PROJECT: Project Redbird – North Improvements (Phase 2)

SUBJECT: Addendum No. 1

PROJECT NUMBER: SNS-0025

This addendum forms a part of the Contract Documents for the Jefferson County Project Redbird – North Improvements (Phase 2). Contractors are required to acknowledge the receipt of addenda by signing and including all addenda with each bid form. FAILURE TO ACKNOWLEDGE RECEIPT OF ADDENDUM MAY SUBJECT BIDDER TO DISQUALIFICATION.

QUANTITIES
SHEET 3 OF 17
PROJECT REDBIRD
NORTH IMPROVEMENTS
(PHASE 2)

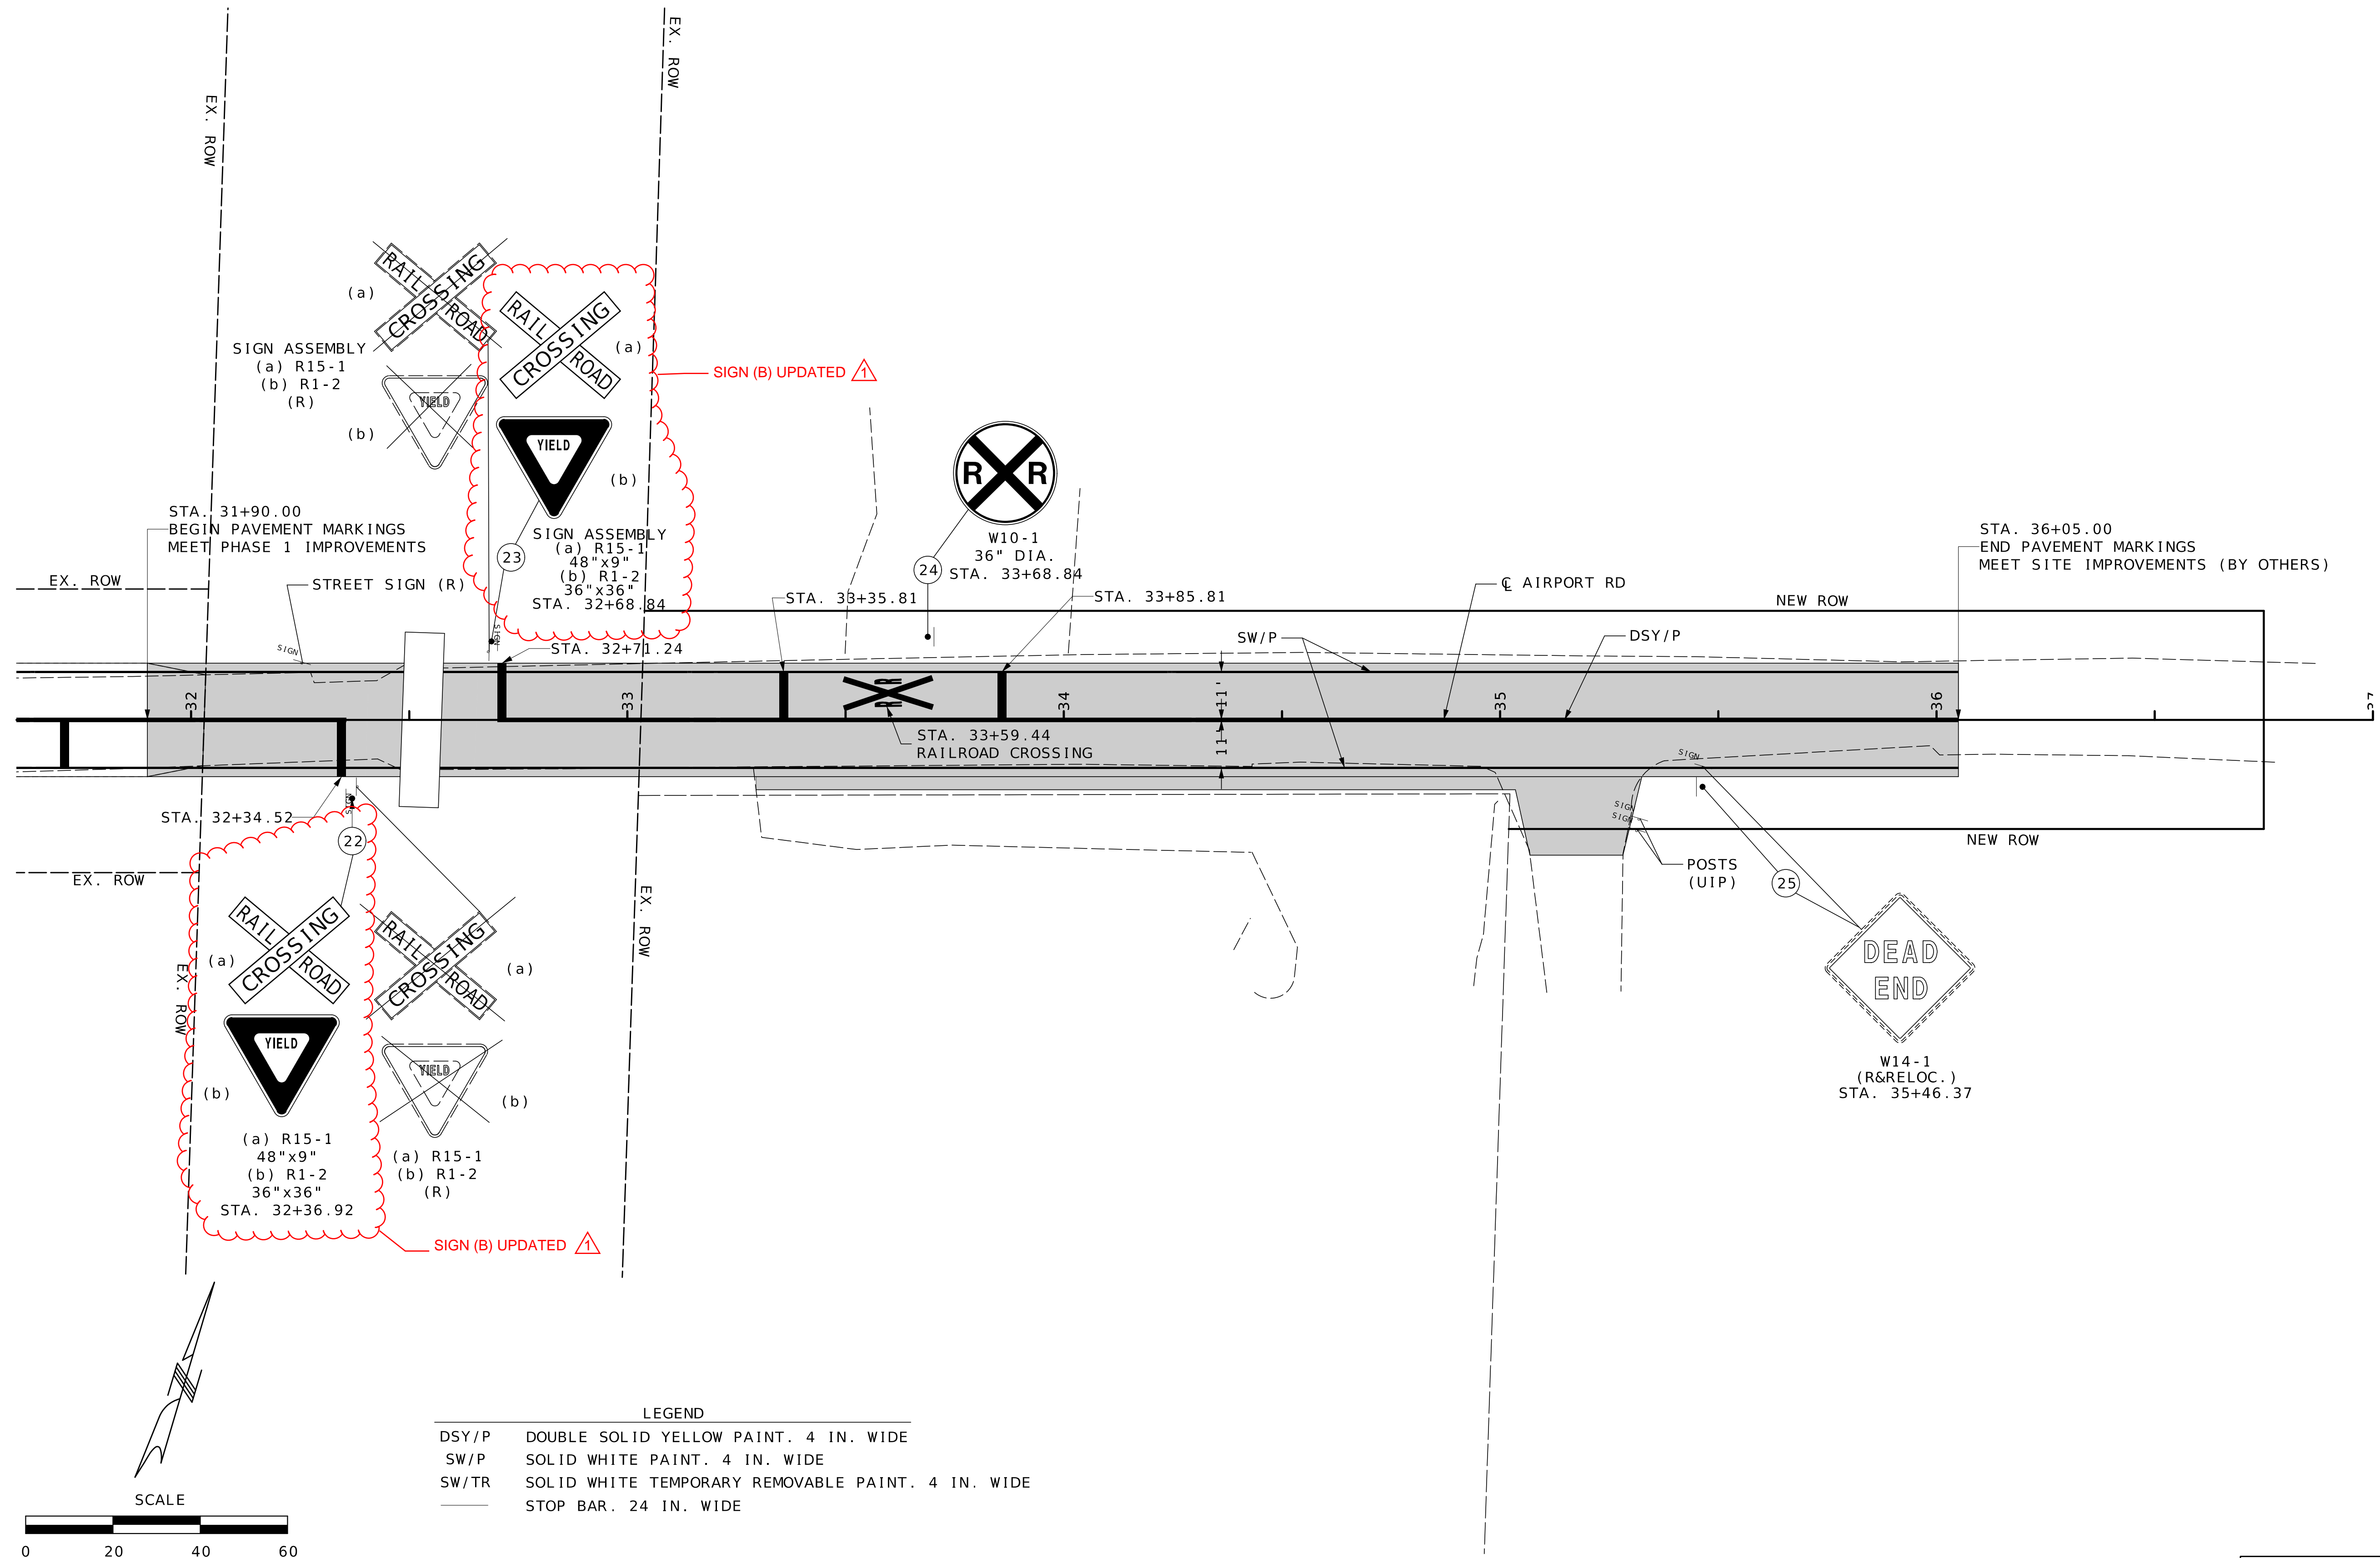
2. Revised Sheet 3, Quantities, Sheet 3 of 17.

Updated SH-Flat Sheet quantity:

- Updated Summary of Quantities for SH-Flat Sheet quantity to 221 S.F.

PAVEMENT MARKING
& SIGNING
SHEET 13 OF 22
PROJECT REDBIRD
SOUTH IMPROVEMENTS
(PHASE 2)

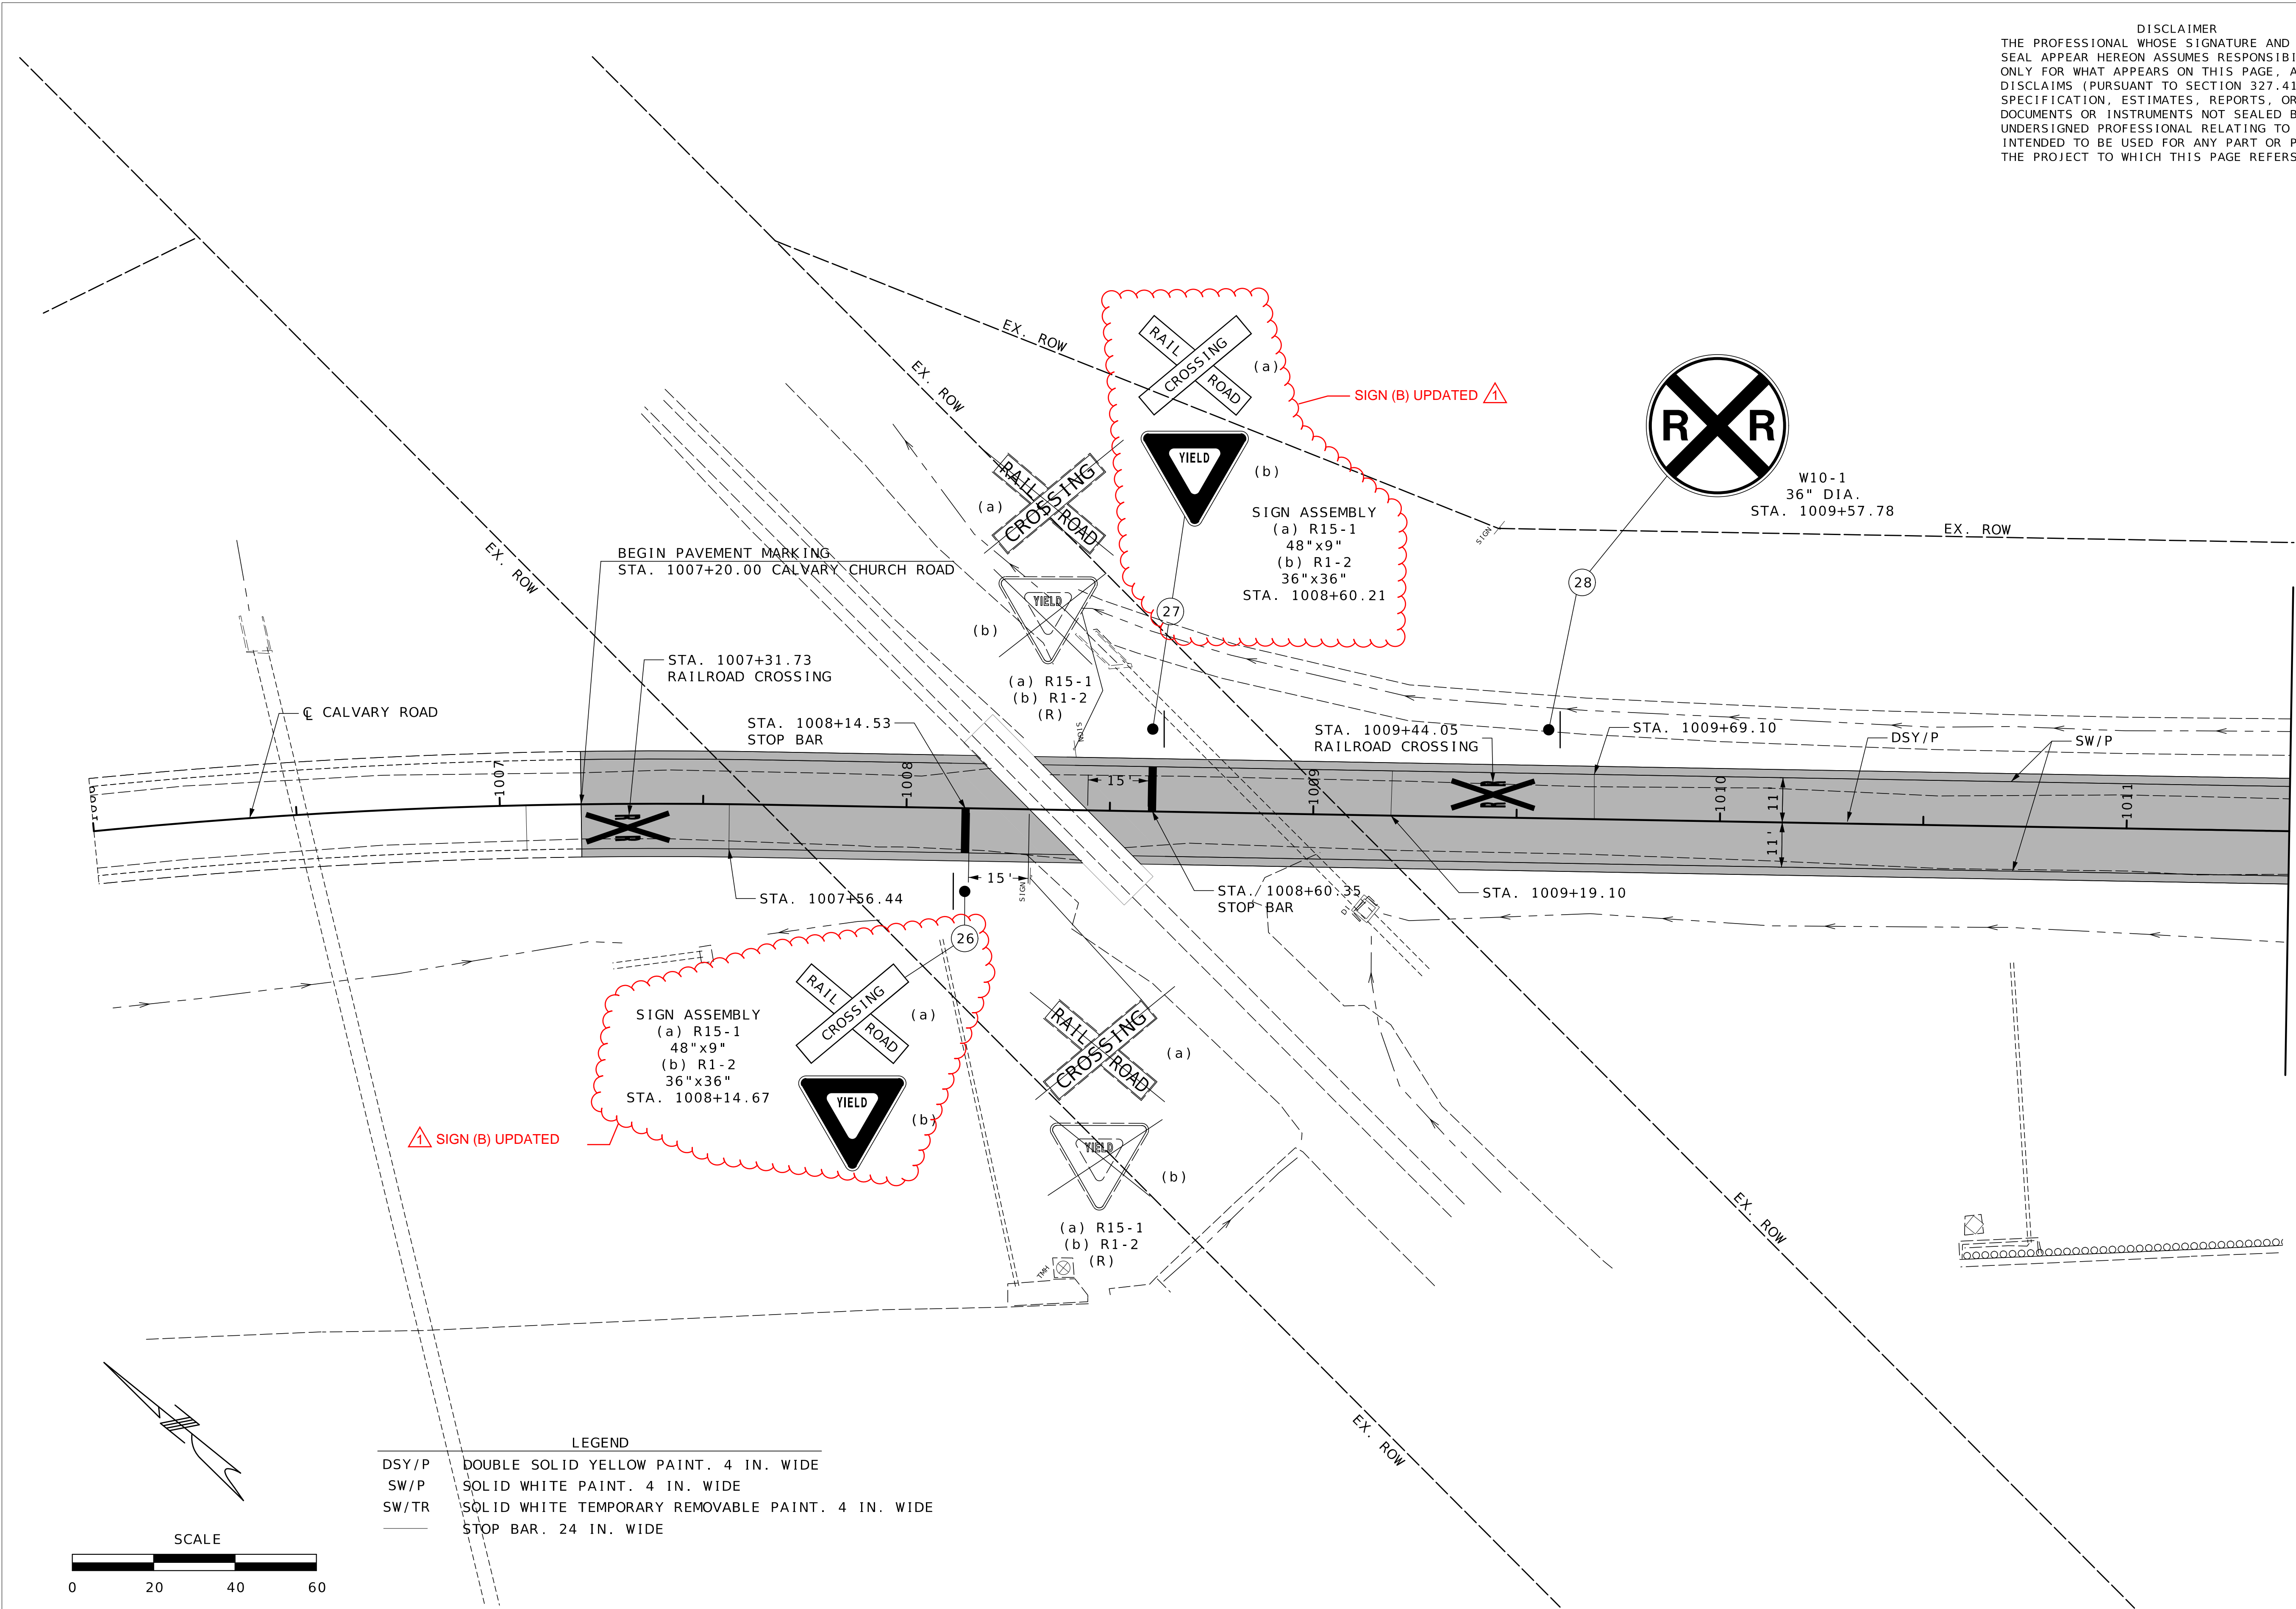
4. Revised Sheet 150 (Pavement Marking & Signing Sheet 13 of 22).

Updated signs 26(b) and 27(b) to yield signs at railroad crossing.

- Revised the signing callouts to say:

“(b) R1-2, 36”x36””

ST PIUS DRIVE
RAILROAD CROSSING
USDOT #371197B

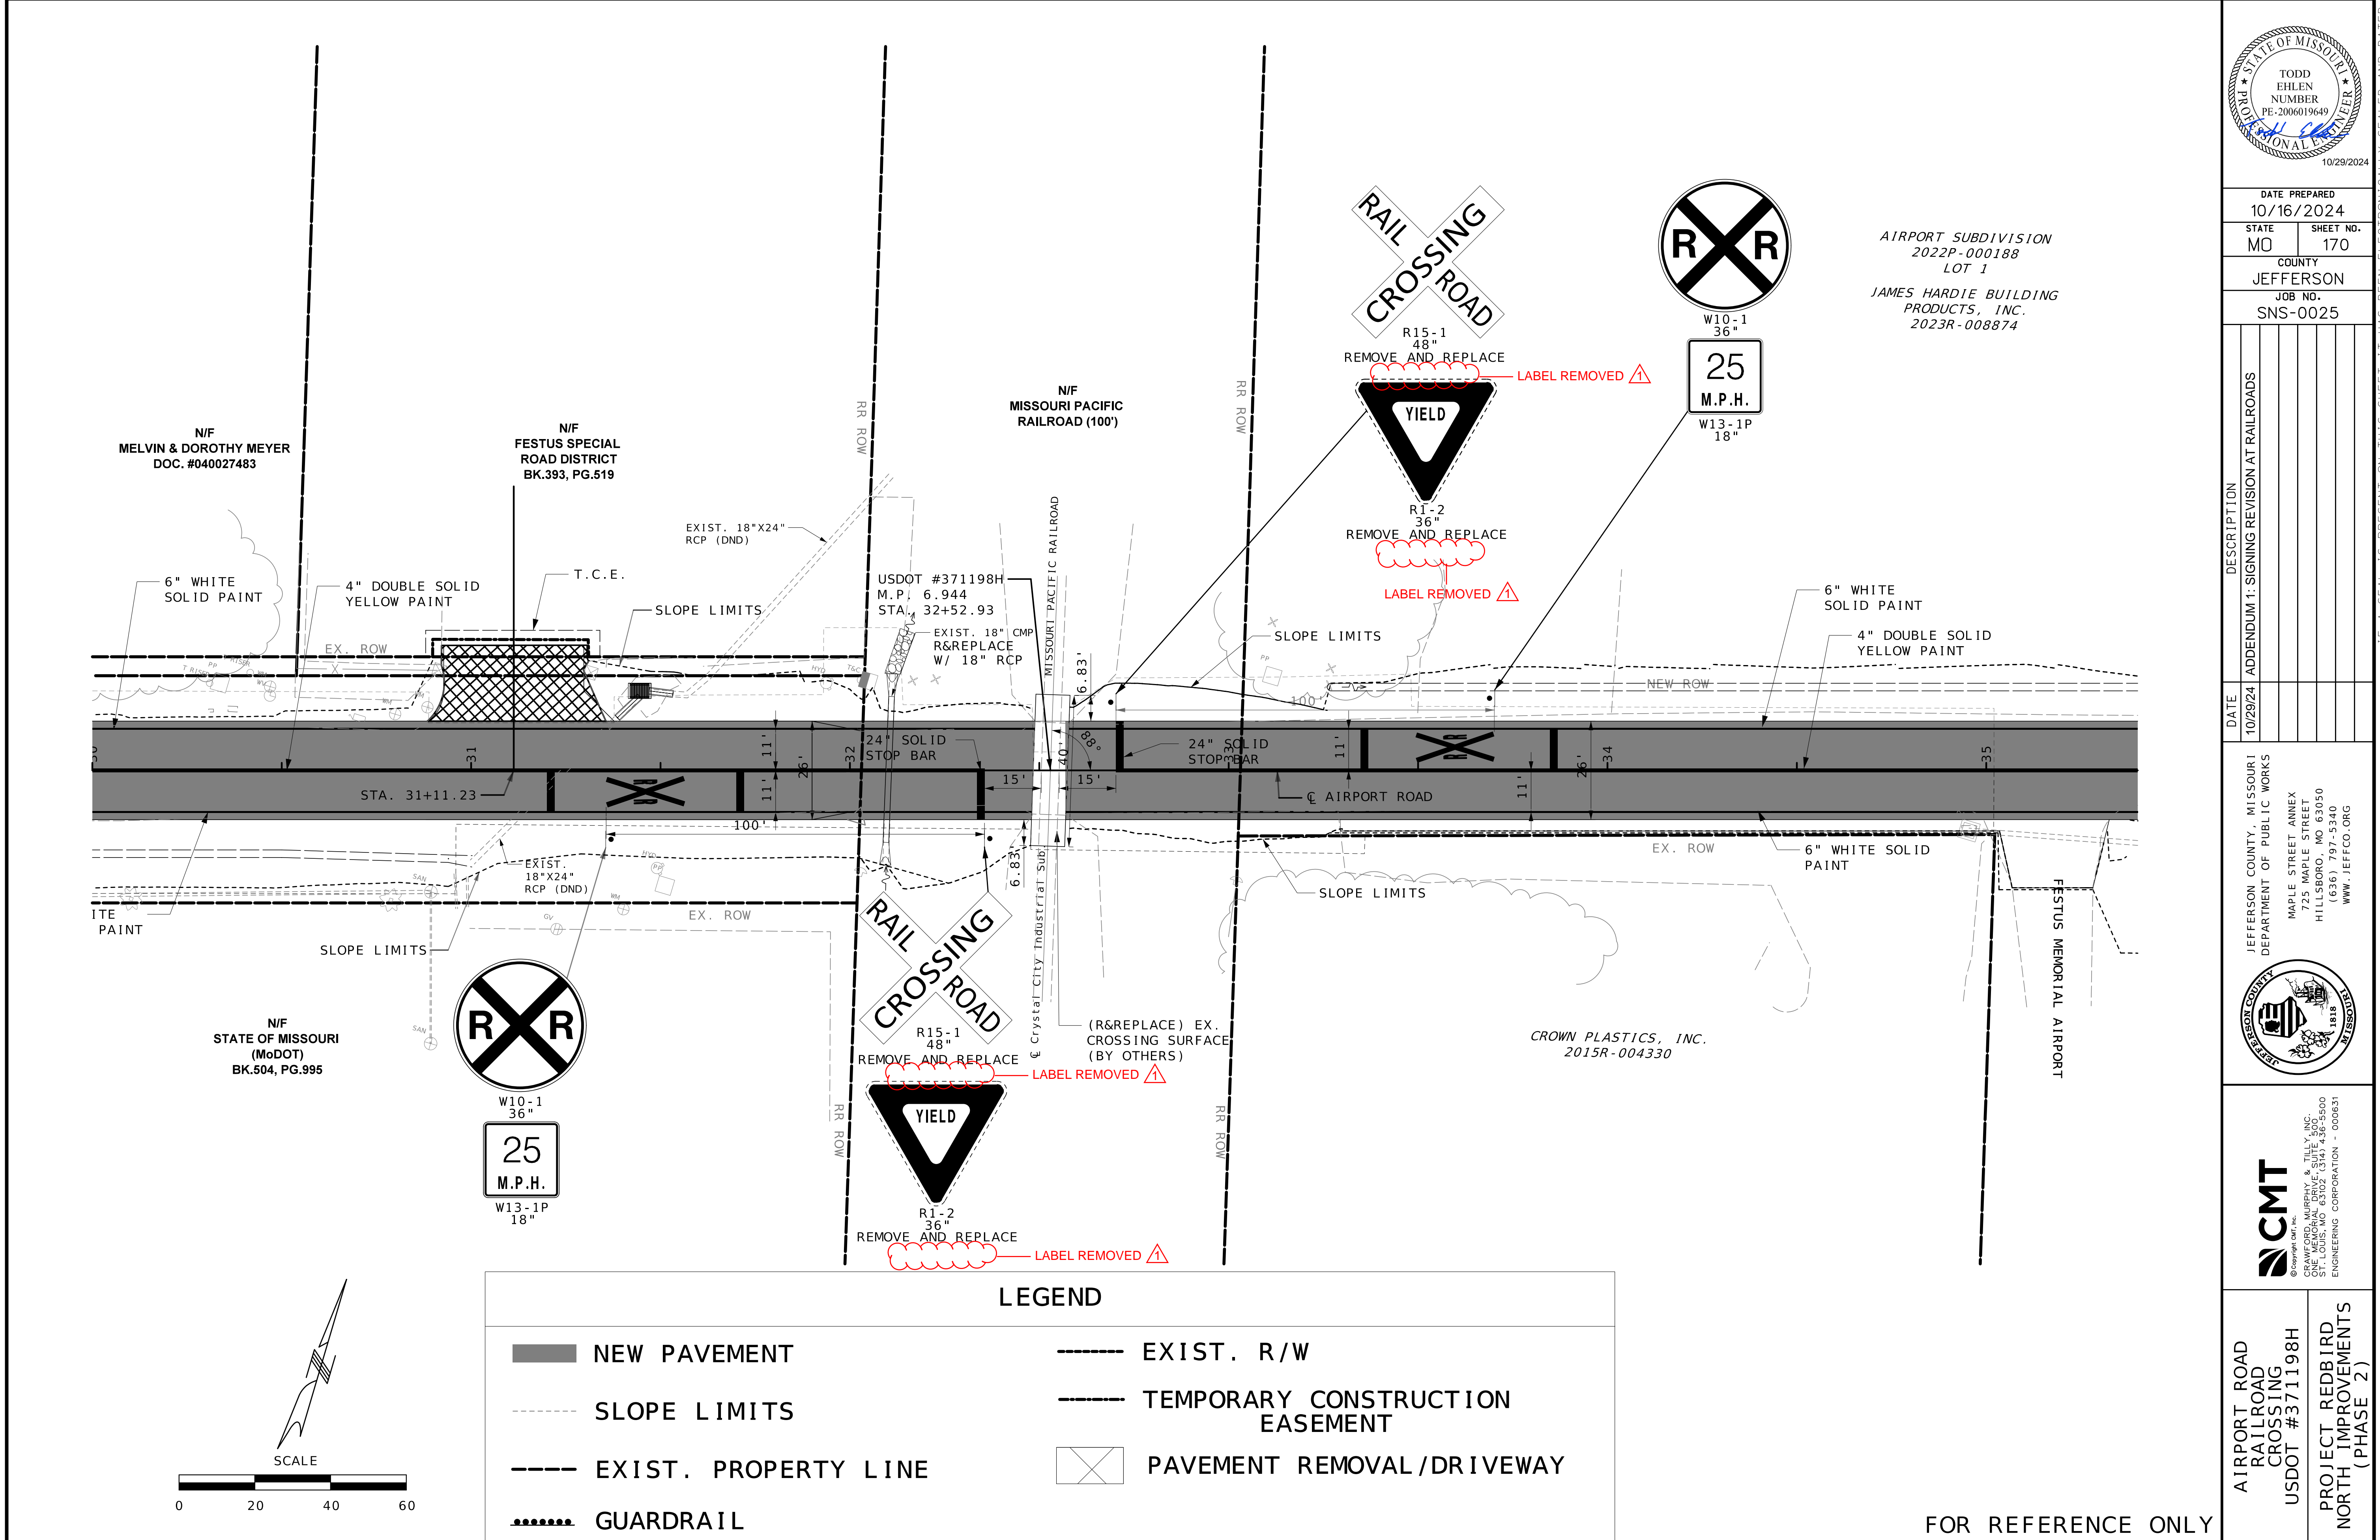
6. Revised Sheet 169 (St. Pius Drive Railroad Crossing)

Revised callouts with sign 2 assembly

- Removed "By Others" from signing callouts
